HISTORIC AND DESIGN REVIEW COMMISSION

March 06, 2019

HDRC CASE NO: 2019-074
ADDRESS: 413 CLUB DR
LEGAL DESCRIPTION: NCB 7014 BLK LOT W 35 FT OF 4 & E 16.5 FT OF 5
ZONING: RM-4, H
CITY COUNCIL DIST.: 7
DISTRICT: Monticello Park Historic District
APPLICANT: Ramiro Reyes
OWNER: Ramiro Reyes
TYPE OF WORK: Window replacement, exterior painting
APPLICATION RECEIVED: February 14, 2019
60-DAY REVIEW: April 13, 2019

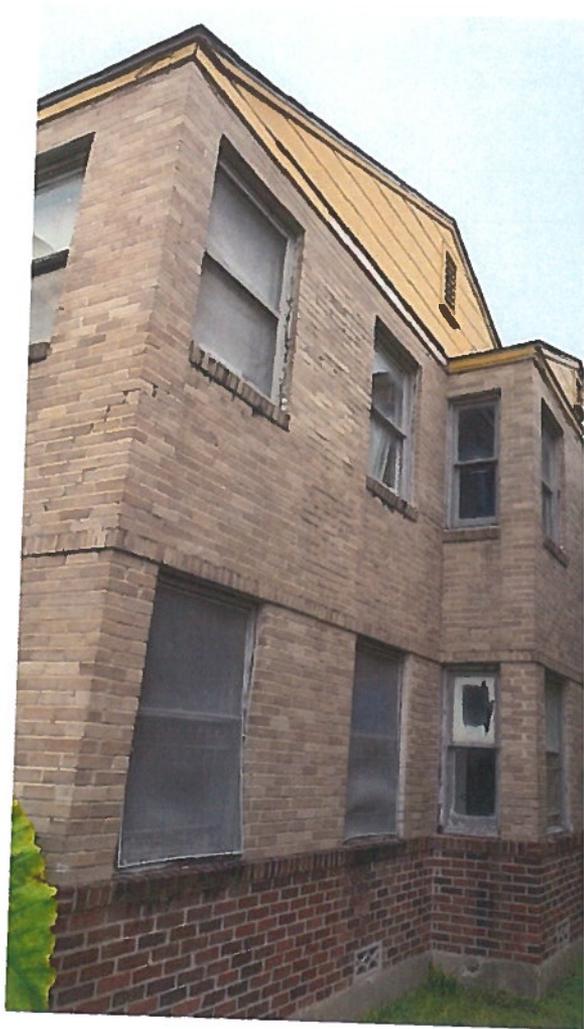
Old windows Left
Pre-Window Installation

old windows Front

Pre-window Installation

old windows

New windows Front side

Post-Window Installation

New windows left side

Post - window installation

New windows Right side

post window installation

New windows back side

Post window installation

New windows

New windows w/ woodsc

New windows w/ New trim

New windows
with wood screens

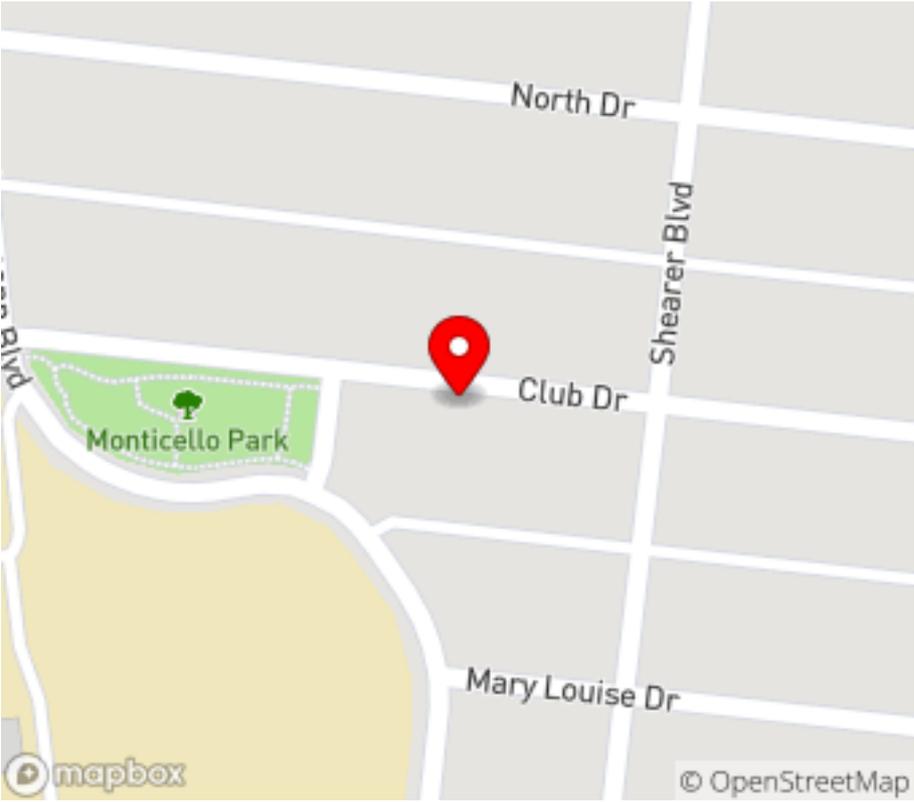
- f. **WINDOW SCREENS** – The applicant has proposed to install wood window screens. Per the Guidelines for Exterior Maintenance and Alterations 6.B.i.x., wood screen window frames should match in profile, size, and design of those historically found when the existing screens are deteriorated beyond repair; the tint of replacement screens should closely match the original screens or those used historically. Staff finds that the proposed window screens are generally consistent with Guidelines.

- ii. Staff recommends approval of the installation of wood window screens based on finding j.
- iii. Staff recommends approval of exterior painting only on wood elements based on findings k; no masonry should be painted.
